KIRK[®] Release Notes
KIRK[®] 6040 KIRK[®] 7040

Firmware Version PCS 07Aa
Q4/2010

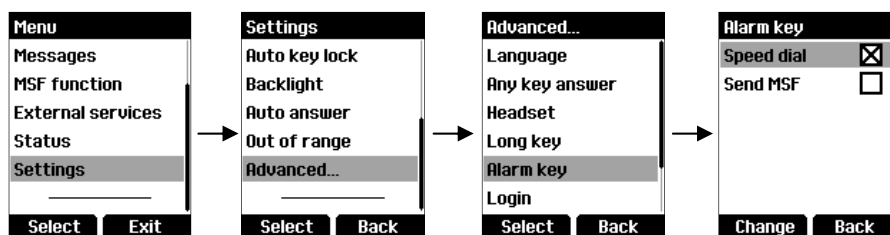
- Portuguese language added.
- Added support for broadcast messaging¹. The messaging format now includes icons.
- During an active voice call, the alert tones of received messages are attenuated by 30dB.
- The speaker gain, when in loudspeaking mode, has been raised by 12dB.
- Ringer tone 2 has been replaced by a low frequency higher volume “digital” ringer tone.
- Ringer tone 3 has been replaced by a high-frequency higher volume “digital” ringer tone.
- The built-in wired headset amplifier² can be configured using the handset menu, see screen dumps below. The selectable amplification range spans from -12dB to +18dB.

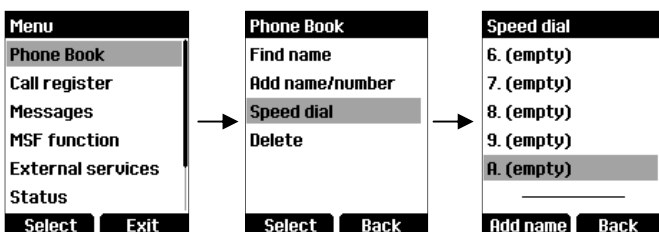
- An entry in the phonebook can be assigned to a long key press on the alarm key. First the alarm key must be configured to use speed dial, see below.

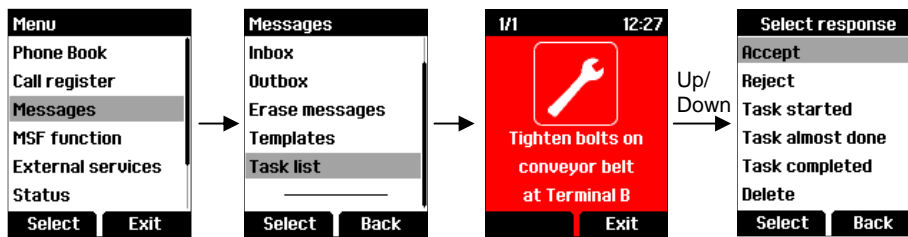
Then speed dial entry “A” must be assigned by selecting Add name:
